**KNOXVILLE HISTORIC ZONING COMMISSION
STAFF REPORT - CERTIFICATE OF APPROPRIATENESS APPLICATION**

PROPERTY ADDRESS: 129 E Oklahoma Ave 37917

FILE NO.: 3-E-16-HZ

MEETING DATE: 3/17/2016

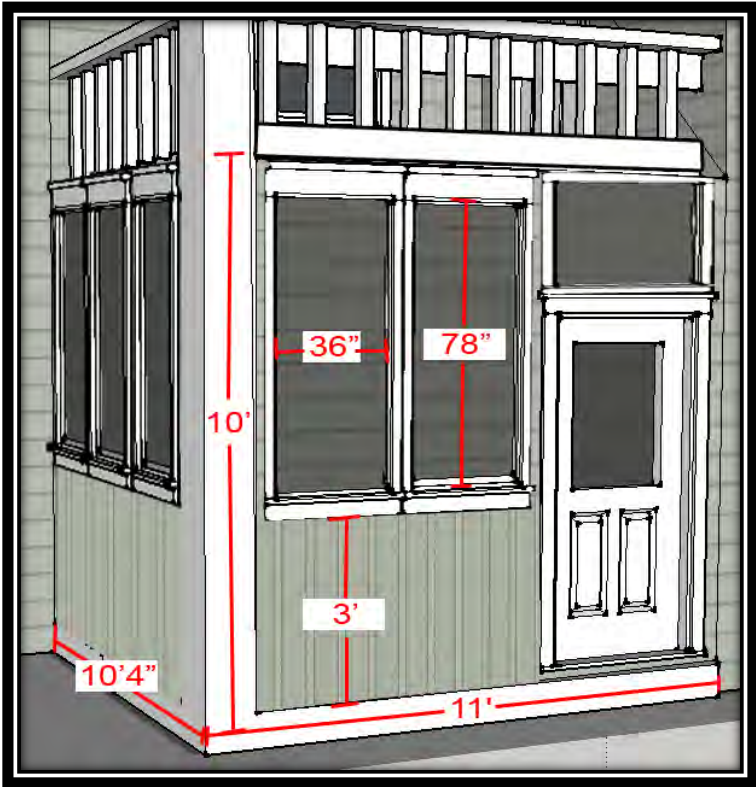
To this end, we propose enclosing the porch area with single light glass windows from 36" above the porch floor to the porch ceiling, on both exterior sides of the porch. 3 windows will be used on the eastern side, and 2 windows and a door/transom on the northern side. The large windows will be ~36"x78" in size.

We would prefer the use of single light fixed windows to be approved, and also to retain the option to use rollout casement windows or double hung windows if desired to allow for airflow. Final window selection will be approved by HZC staff before purchase.

The door will be a 1/2 sash front door, repurposed from the front of the house, with a transom window added above. We would use a vertical siding below the windows.

Approve enclosure of lower rear porch as per submitted drawing (4-21-2016) with condition that type of window -- casement vs. double-hung -- to be approved by staff, as well as wood vertical wainscotting type below windows.

129 Ok – Possible diamond-shaped window framing at front porch

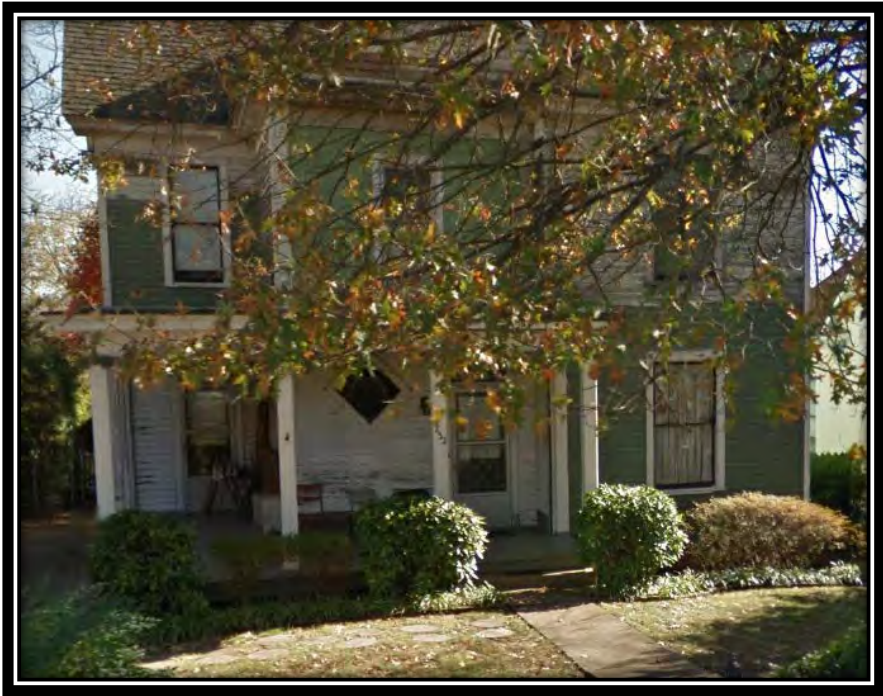
- 4) There is evidence in the front wall framing that there may have originally been a small diamond-shaped window to the right of the front door.
- 5) There are many examples of small windows of various shapes, including diamonds, adjacent to front entry doors throughout the historic districts.

1. After removing the sheathing on the front porch, there is definitive evidence in the revealed framing that a diamond-shaped window existed to the right of the original front door opening.
2. Plumbing lines found on the rear porch lower level indicate the porch was likely enclosed at some point, but there is no documentation on the appearance of the enclosure or when it occurred. However, the prior enclosure confirms that the existing lower level porch structure has been altered from the original.
3. The proposed enclosure on the lower level retains a level of transparency and porch character with a sleeping porch-type arrangement of windows on each side with wood vertical wainscotting below.
4. The 2nd-level porch was a later addition since it does not show as existing on the 1917 Sanborn maps. It was never enclosed, so it is appropriate that it should remain open.

At the last month's meeting, the commission was unable to grant approval for the requested installation of a diamond shaped window on the front porch due to lack of evidence. Although there was half of a diamond shape framed into the interior wall next to the existing doorway, it was unclear if it was anything more than bracing.

However, since the last meeting, we have removed the cement shingle from the porch area, and discovered additional support for the window. From the front, you can see in the same area that the siding had been cut in a diamond shape, and plywood added in the area before the cement shingles were installed.

Approve installation of diamond-shaped window to the right of the original front door opening with condition that wood framing based on submitted documentation of historical existence with framing to match type and width of that which existed on original window openings.
